Town of Hilton Head Island Regular Design Review Board Meeting

February 23, 2016

AGENDA

TIKI HUT REMODEL/ADDITION SECTIONS, AND CALCULATIONS	
PROJECT NAME: 600 CYPRESS TIKI HUTS S.C. BEACH HOUSE PROJECT	
SCALE: 1/8"=1'	SHEET 1 OF 1

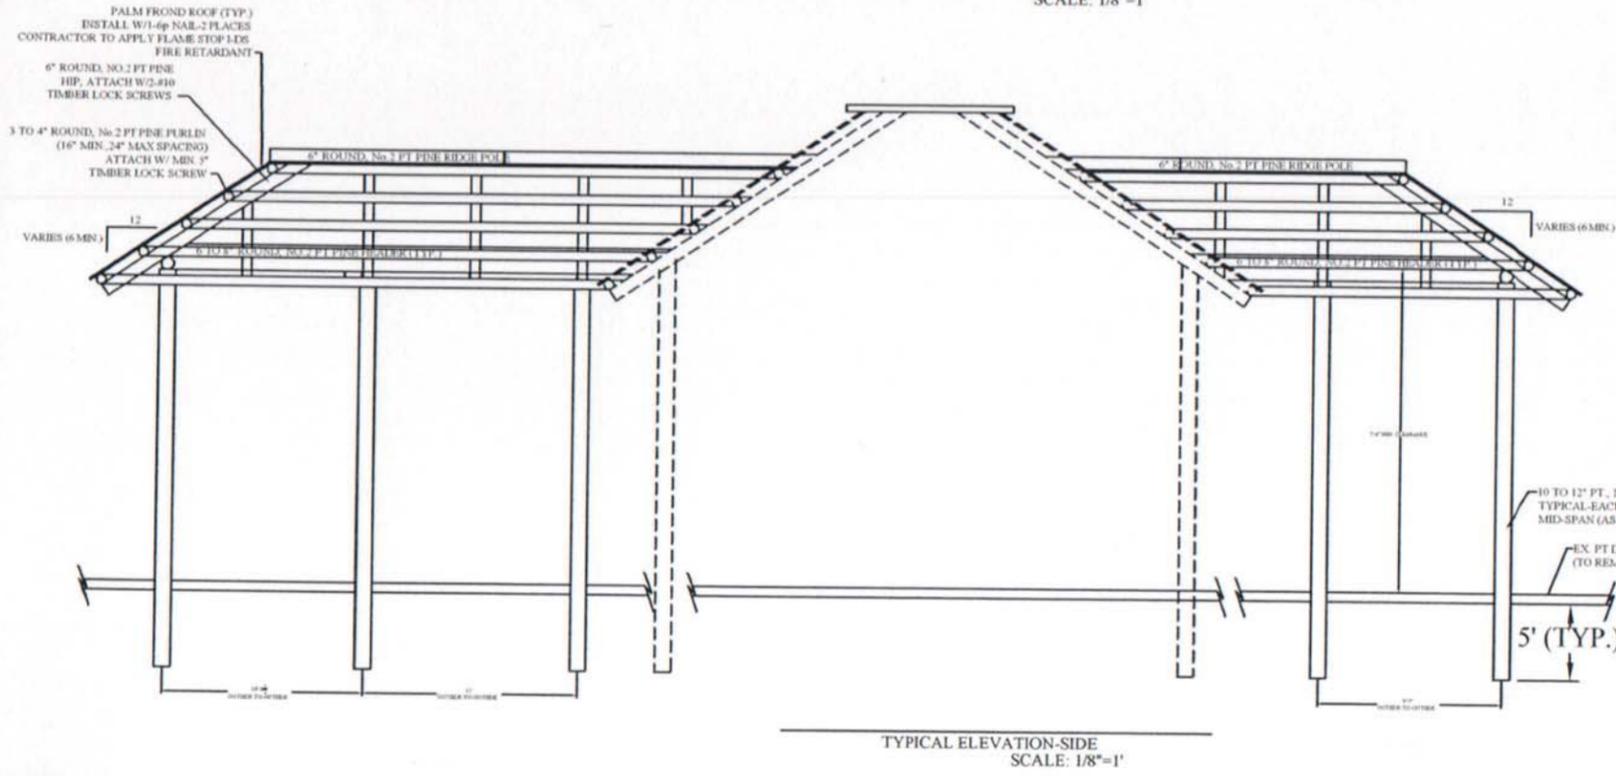
Applicant proposes to remove semi-permanent umbrellas adjacent to existing tiki hut and replace them with and expanded tiki hut. A more uniform/appropriately sized enclosure system should be considered for new structure.

HARBOURSIDE: PROPOSED WEST ENTRY
(match ex. colors/textures)

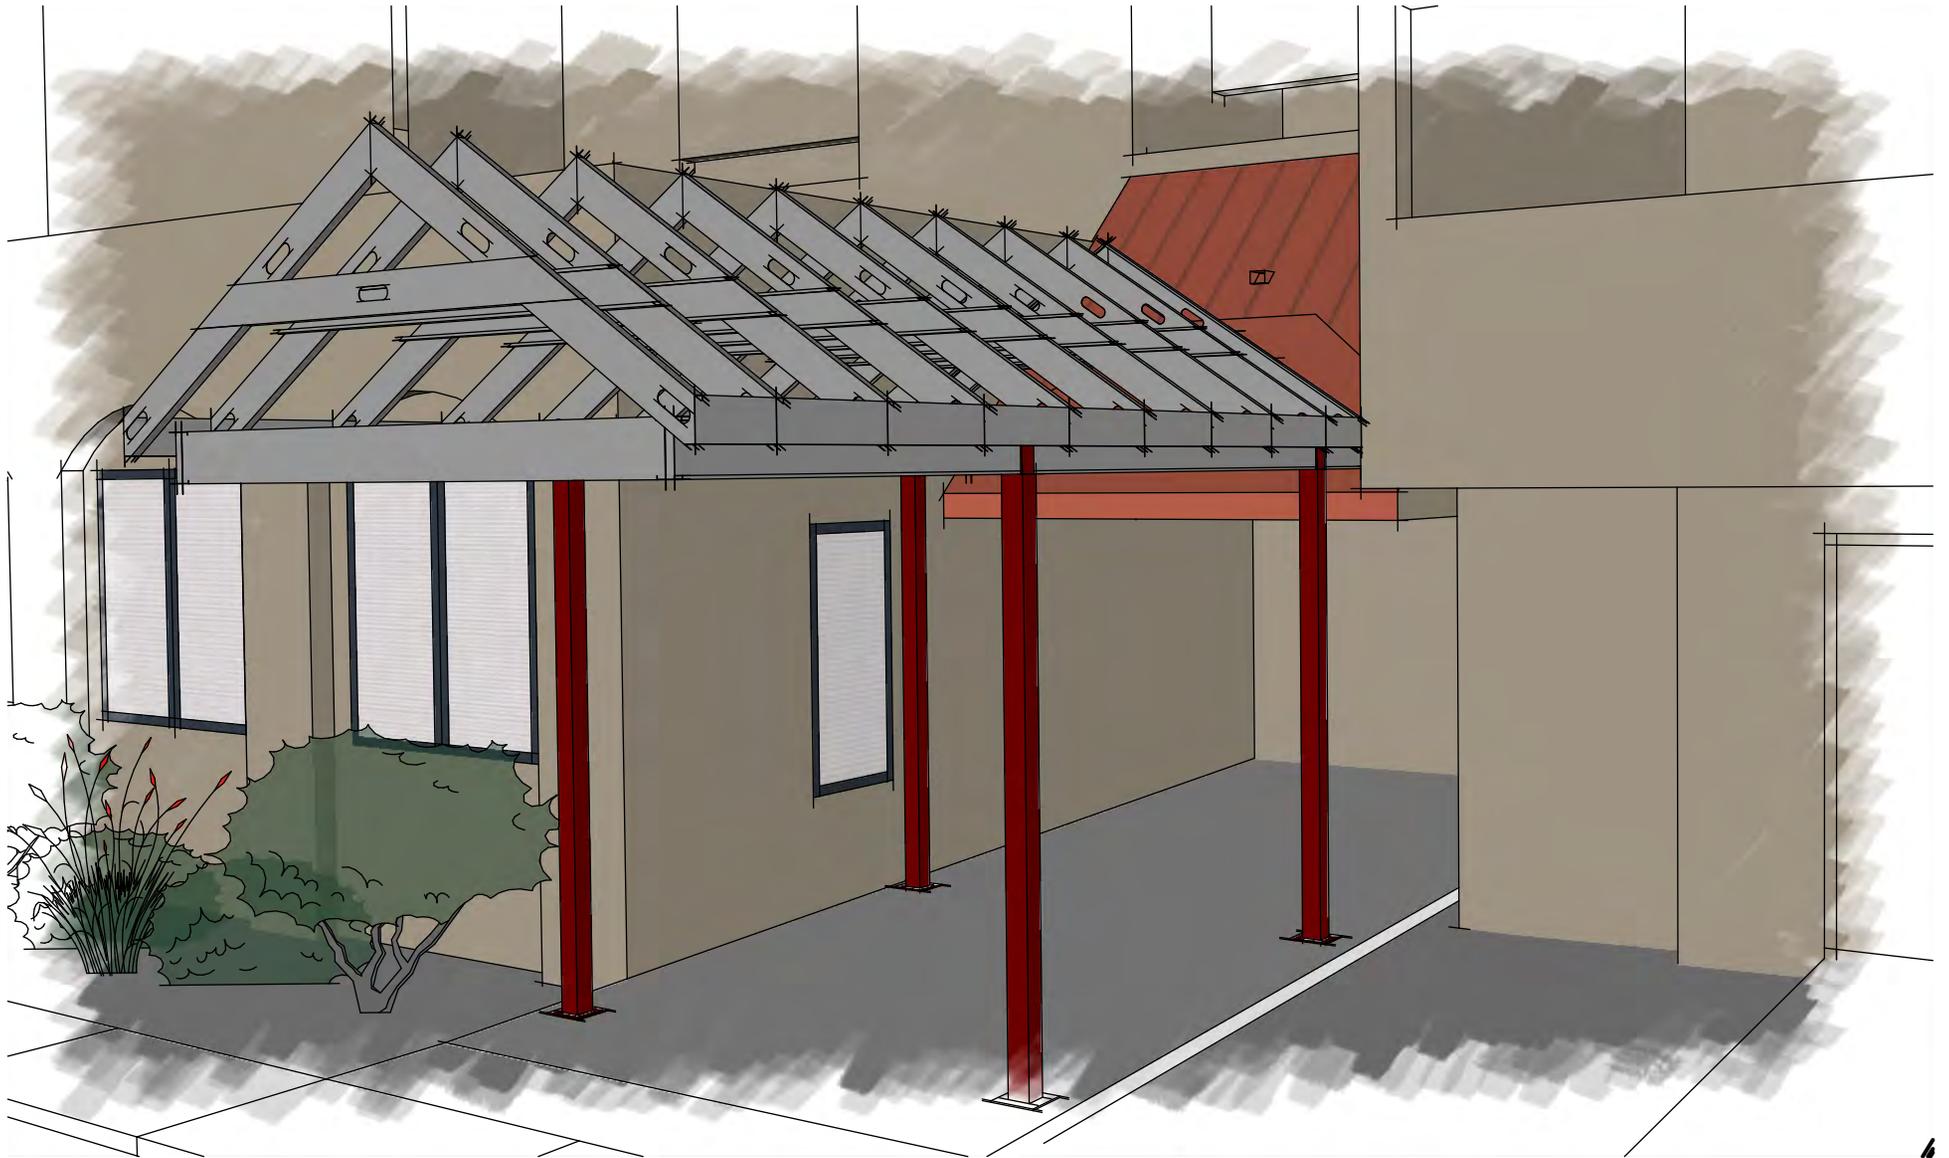
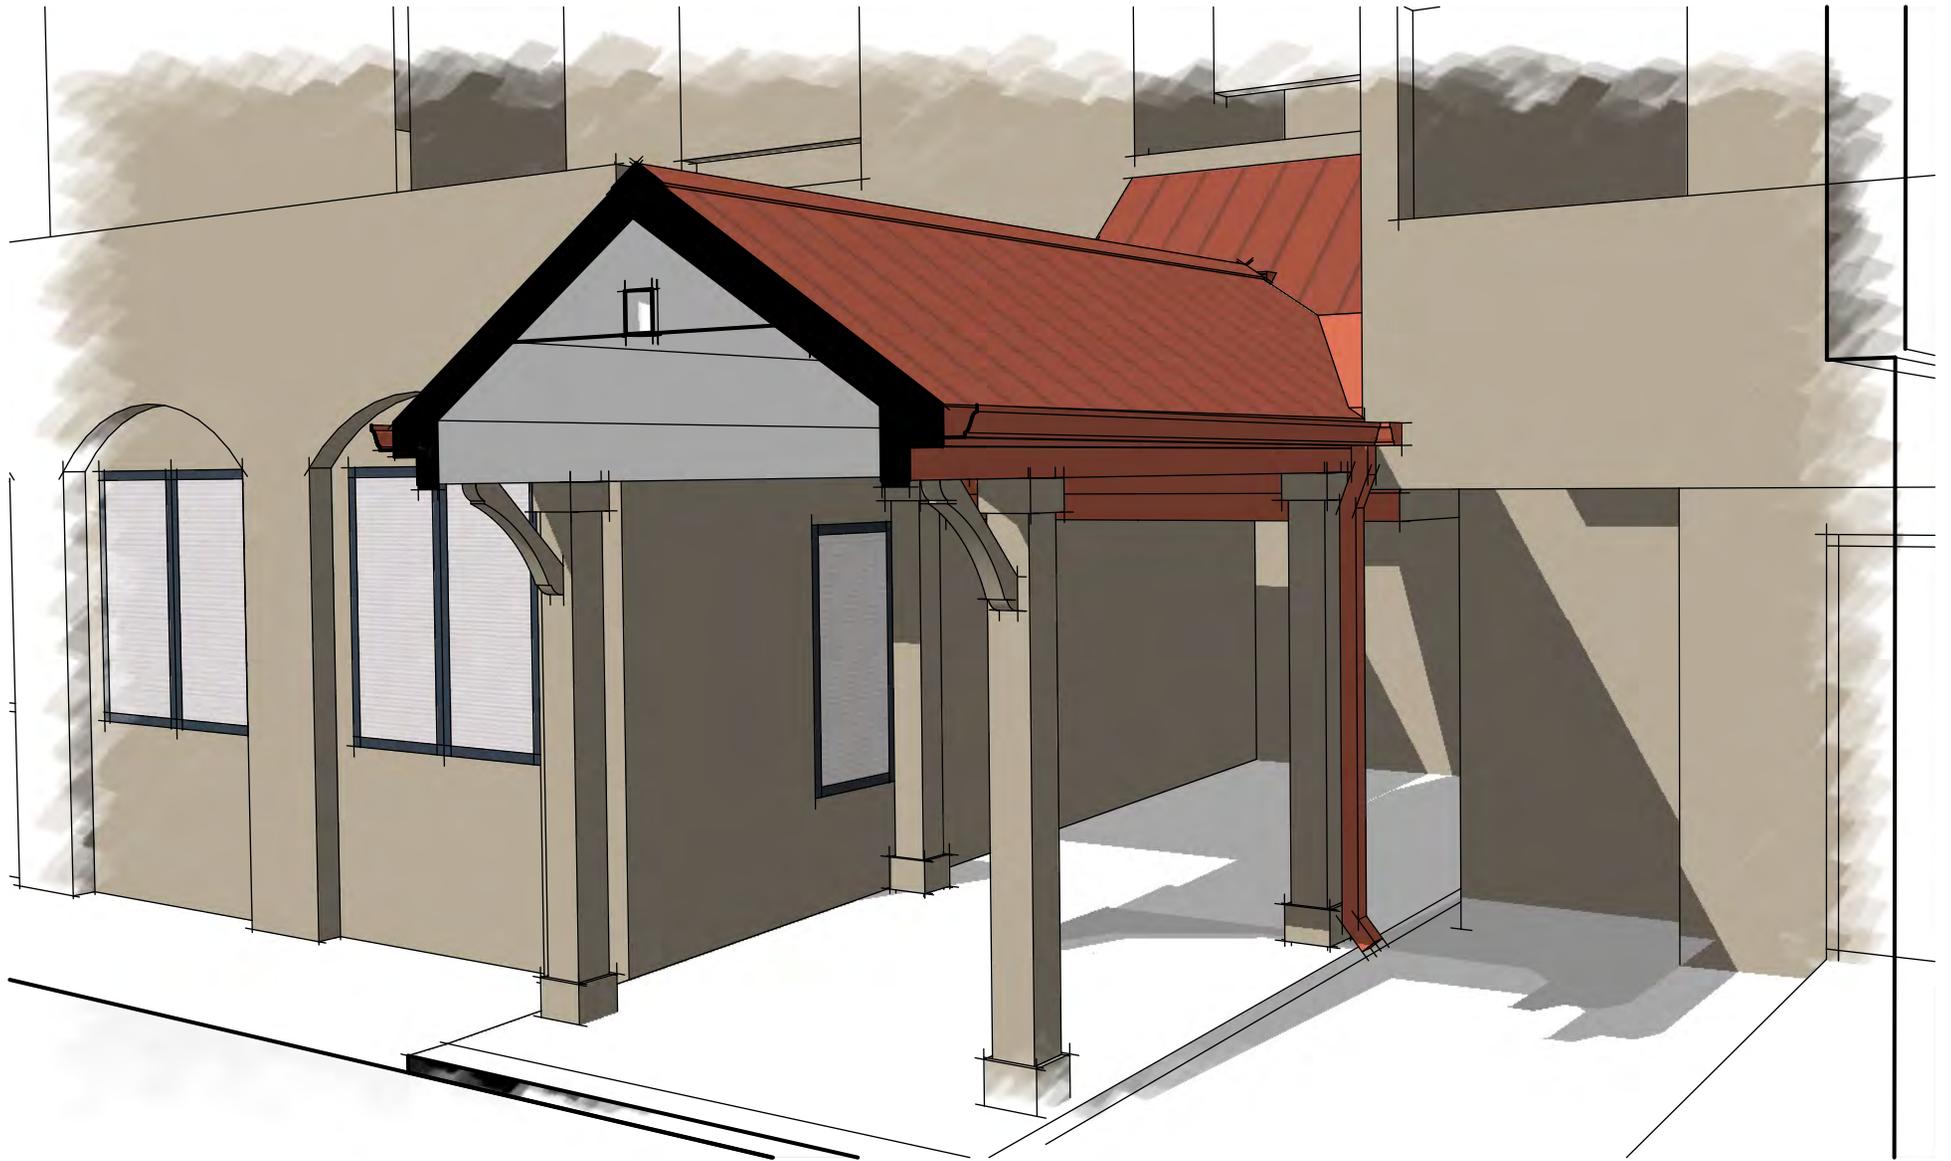
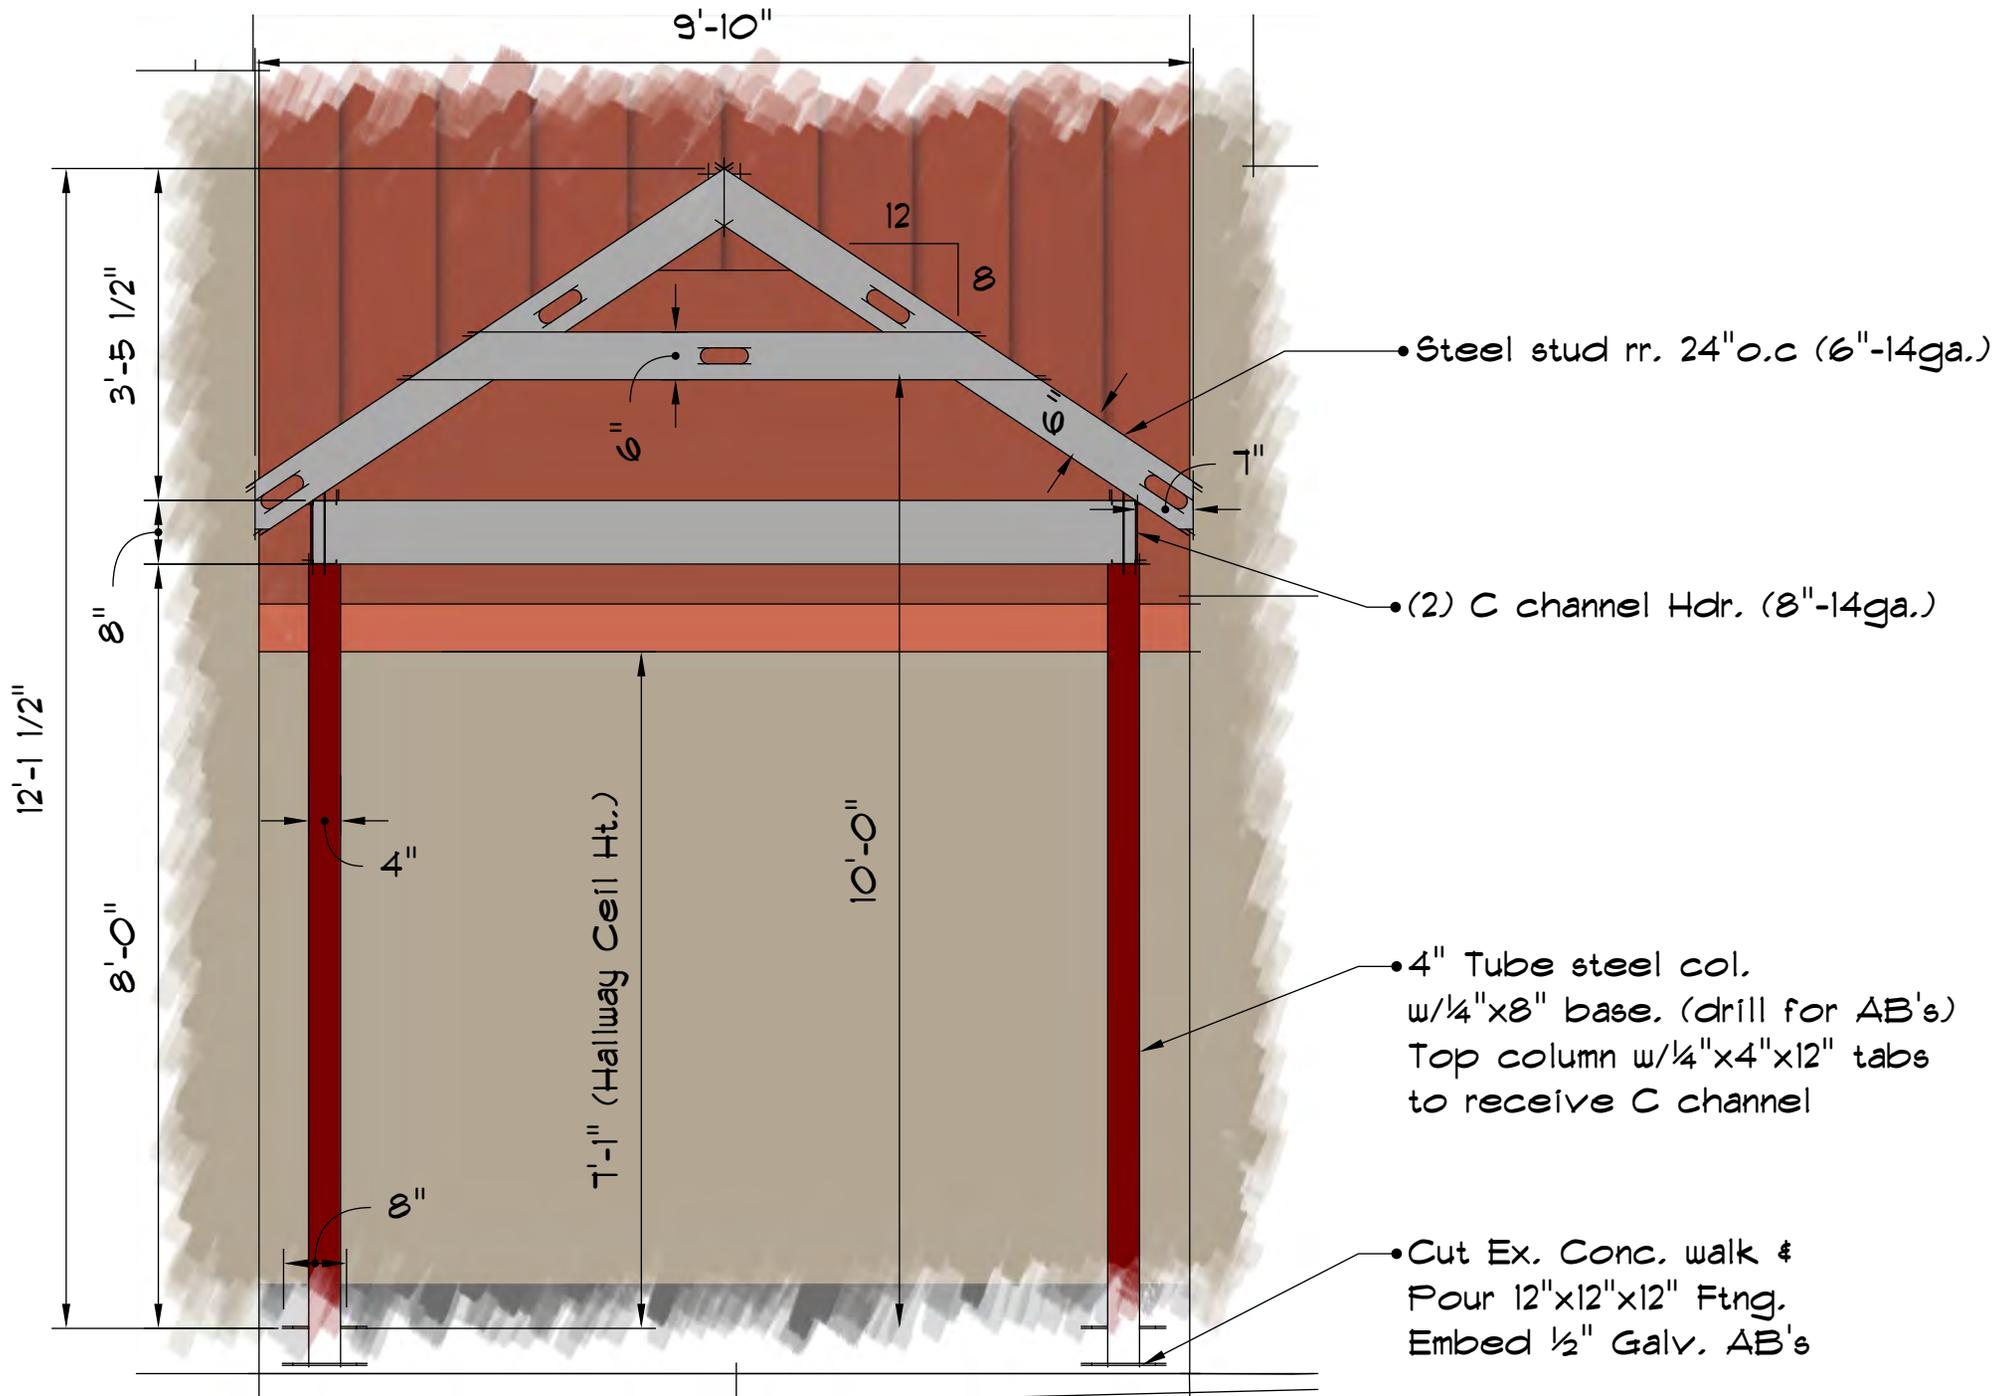
Applicant proposes to replace existing canvas awnings to match roof replacement. Colors (terra cotta) and materials (stucco, wood, metal roof) are consistent with existing.
